Subject: Zion Nuclear Station Unit 2  
 Second Interval Inservice Inspection  
 Program Relief Request  
NRC Docket No. 50-304

RELIEF REQUEST IWB-15

RELIEF REQUEST IWB-16

FIGURE B12

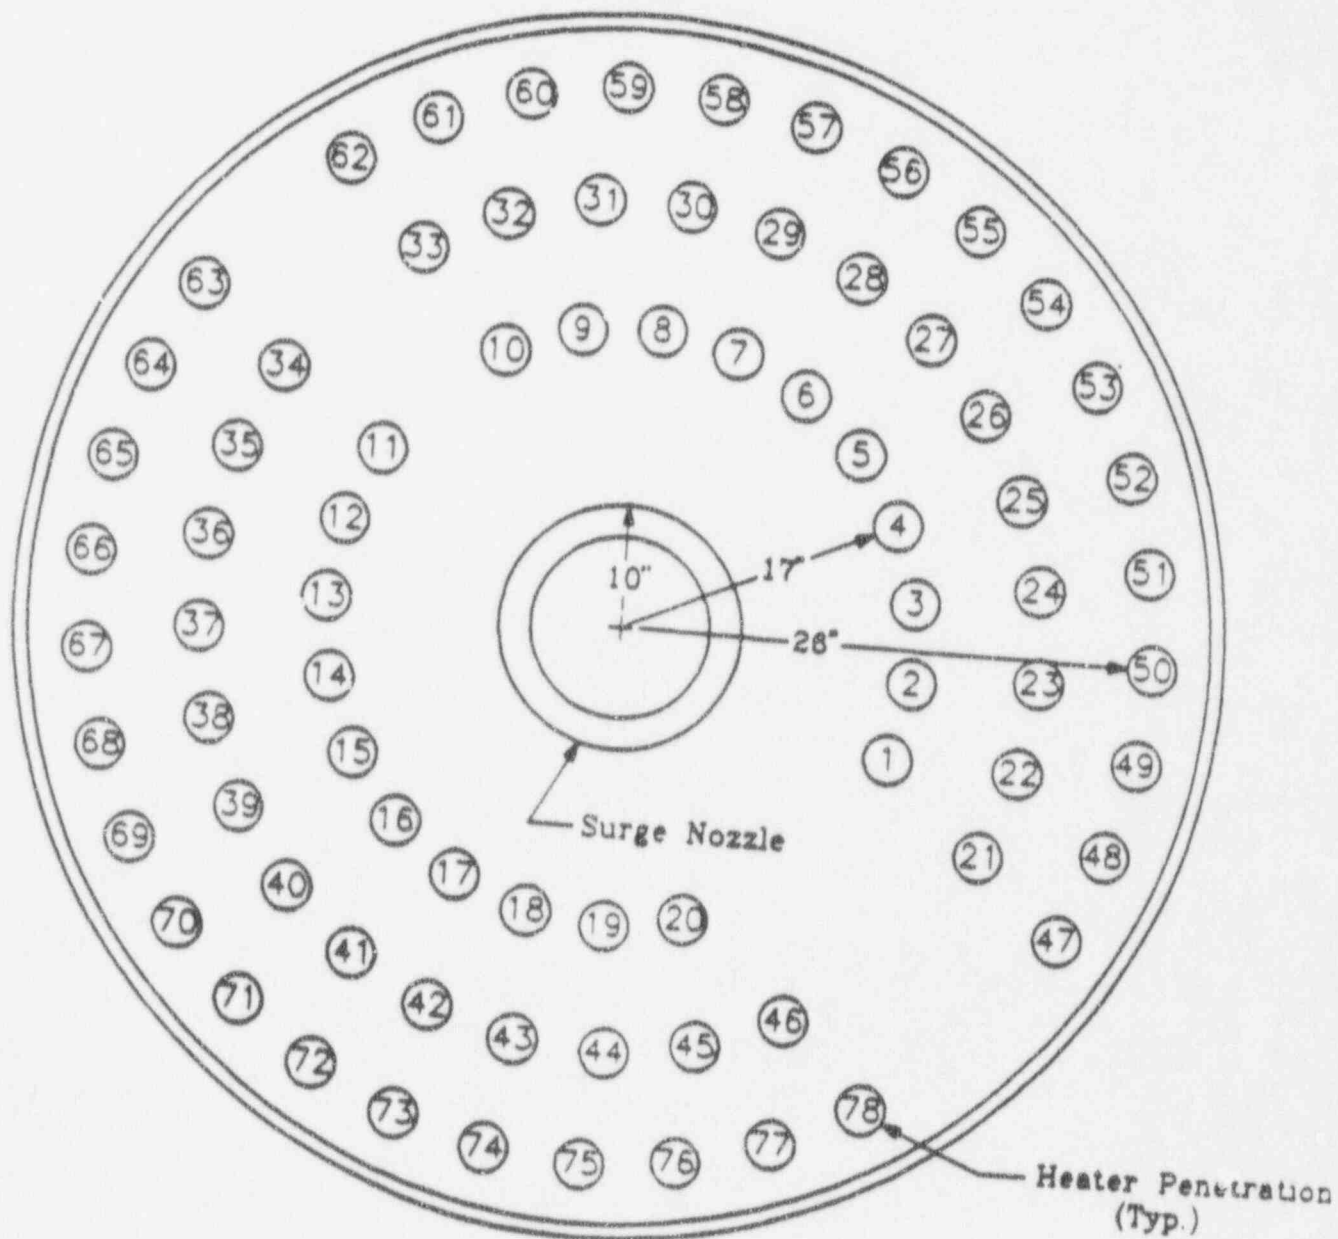
The lower head of the pressurizer is covered by 4 inch thick multi-layered stainless steel mirror insulation which was not designed for removal. In order to remove the insulation, the 78 pressurizer heater cables would have to be disconnected (reference Zion figures B12 and B13) and each of the 78 convection stops which are riveted to the insulation would have to be cut and removed so that the insulation could be removed over the pressurizer heaters (reference Zion figure B14). The lower head insulation is supported by structural steel that is attached to the support skirt and presents an additional barrier that prohibits access to surface area C-D. The structural steel will also need to be removed in order to access area C-D.

FIGURE B15

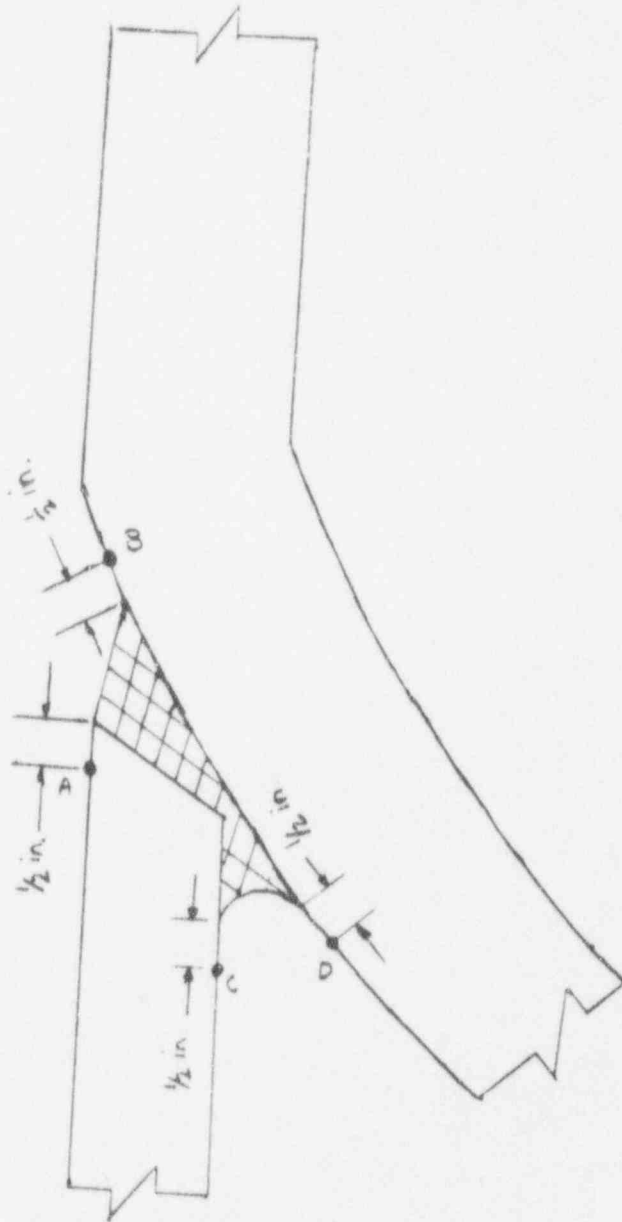
The Pressurizer Vessel to Support Skirt Integral Attachment Weld is best represented by ASME Section XI Figure IWB-2500-13 (reference Zion figure B15 for Zion Unit's configuration). Tight clearances beneath the pressurizer prohibit physical access for surface preparation and inspection of surface area C-D of figure IWB-2500-13 (shown in Zion figure B15) of the pressurizer support skirt to vessel integral attachment weld. In addition, insulation and associated support steel on the lower head of the pressurizer hinder access to the examination surface. The removal of the insulations covering the lower pressurizer head will result in high radiation exposure to plant personnel.

In order to perform exams on area C-D of figure IWB-2500-13, the surface area must be accessible for proper surface preparation and examination. Area C-D is not accessible since the insulation covering the lower head of the pressurizer was not designed to be removed. In addition, adequate weld preparation and inspection is not physically possible due to the tight clearances beneath the pressurizer.

The compressive loading on the support, as well as, the mild environmental does not favor the initiation of service induced flaws in the weld. Examination of surface A-B of Figure IWB-2500-13 would result in adequate information to evaluate the integrity of the weld.

Surface examination will continue to be performed on surface area A-B. In addition, the support skirt will receive a VT-3 examination.
